Independent Competition and Regulatory Commission

Enlarged Cotter Dam Water Security Project
Investigation

Final Report

Halcrow Pacific Pty Ltd

Figure 3.1: Possible Alternative to Left Abutment Excavation

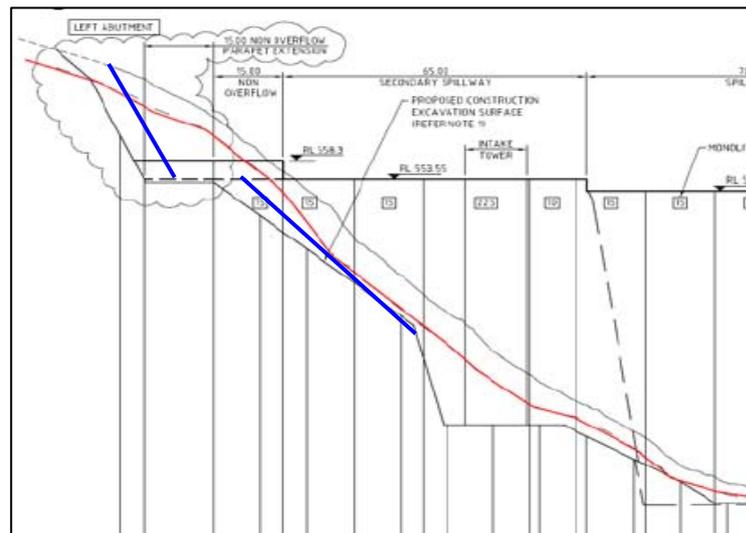
- High on the left abutment, where the access road cuts deeply into the abutment, it appears that the foundation slope could be steepened locally, thereby reducing the road cut width by approximately seven metres (assuming that the minimum excavation line is the same upstream and downstream of the dam). This would slightly increase the gradient of the top section of the side spillway chute, resulting in a limited saving in excavation, although would not result in a significant savings in RCC, as the dam section at this elevation is narrow. One problem with steepening the upper section of the excavated slope would be drilling at the base of this slope for pre-splitting the flatter slope below, and this may be the reason for adopting the arrangement shown. The blue lines on **Figure 3.1** (extract from Figure 1.3.10, section 1.3 of the TOC report⁵⁶) show a possible alternative.

Figure 3.2: Possible Alternative Approach to Upstream Batter

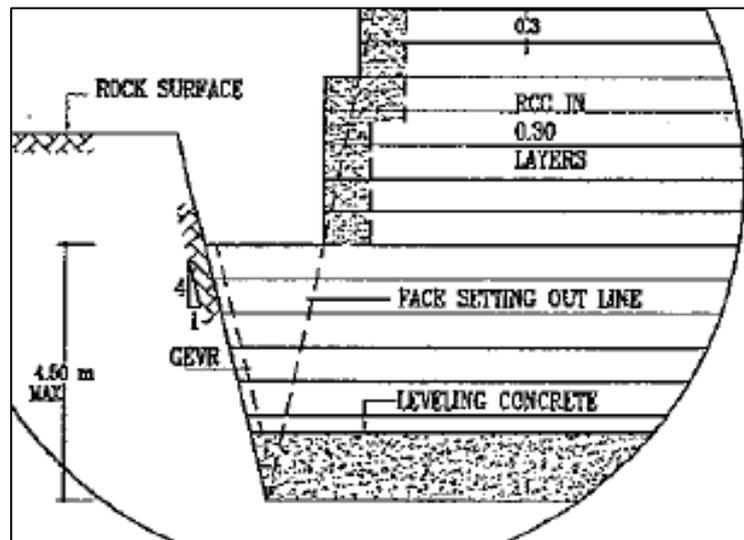
- “Excavation extents” (refer section 1.3 of the TOC report⁵⁷) notes that the upstream batters are set between two to three metres back from the dam faces to allow room for placing formwork. While used on some dams, this is not the only approach. The alternative is to end the batter approximately one metre back from the upstream face line and on the downstream face line and fill against the rock batter with RCC until there is room to place formwork; refer to **Figure 3.2** for a suggested sketch. This would reduce the excavation volume, but marginally increase the RCC volume.

Figure D.1: Possible Alternative to Left Abutment Excavation

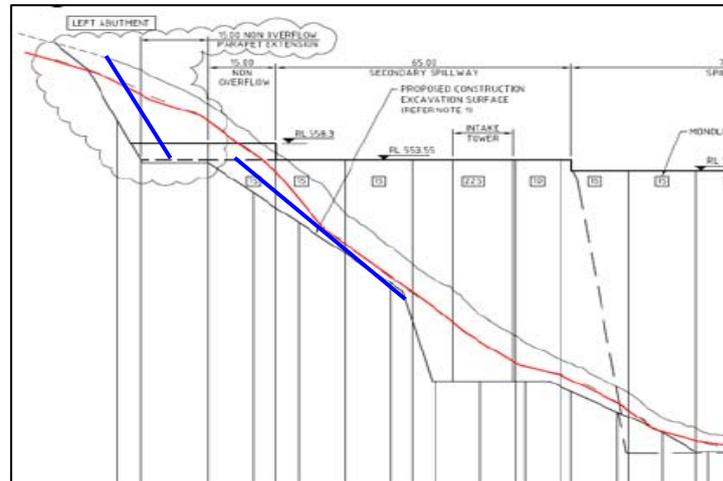
- High on the left abutment, where the access road cuts deeply into the abutment. It looks as though the foundation slope here could have been steepened locally, thereby reducing the road cut width by about 7 metres, assuming that the minimum excavation line is the same upstream and downstream of the dam. This would increase the gradient of the top section of the side spillway chute, but not excessively. This would provide a limited saving in excavation, but not much in RCC, as the dam section at this elevation is narrow. One problem with steepening the upper section of the excavated slope would be drilling at the base of this slope for pre-splitting the flatter slope below, and this may be the reason for adopting the arrangement shown. The blue lines on **Figure D.1** (derived from Figure 1.3.10 of the TOC report) identify a possible alternative.

Figure D.2: Possible Alternative Approach to Upstream Batter

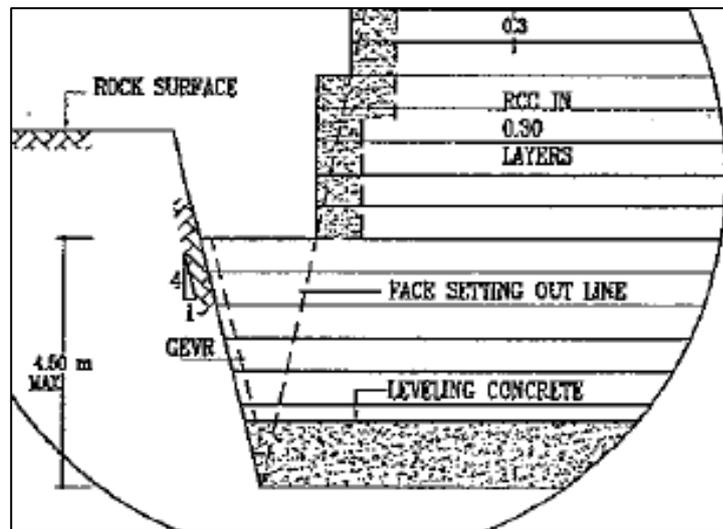
The alternative approach is to end the batter approximately 1 metre back from the upstream face line and on the downstream face line and fill against the rock batter with RCC until there is room to place formwork, as shown on **Figure D.2**. This would reduce the excavation volume, but marginally increase the RCC volume.
